Re: **Town of Dedham  
Oakdale Elementary School Project  
Preferred Schematic Report Submission**

## Preferred Schematic Report

Oakdale Elementary School, Dedham, Massachusetts

### **1.6 MSBA PDP Review and Response**

**Figure 1: DPS SELECTED STUDENT POPULATIONS \*\***

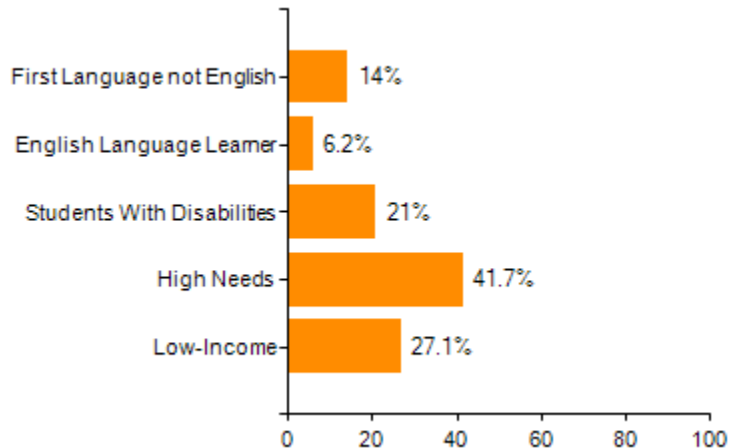
*14) The information provided on page 3 of the District's educational program states: "42% of Dedham's students fall into the high needs category established by the Department of Elementary and Secondary Education." The associated bar graph referred to as "Figure 1: DSP Selected Student Populations" provided on page 3 of the District's educational program totals 110% rather than 100%. In response to these review comments, please review the bar chart and provide the number of students for each of the selected student populations identified.*

Response: The bar graph on page 3 does not total 100% because of the fact that DPS students can be represented in multiple categories. For example a 6 year old first grader who is identified as low income and an English Language Learner would be counted and represented in the percentage of English Language Learners and in the percentage of low income students.
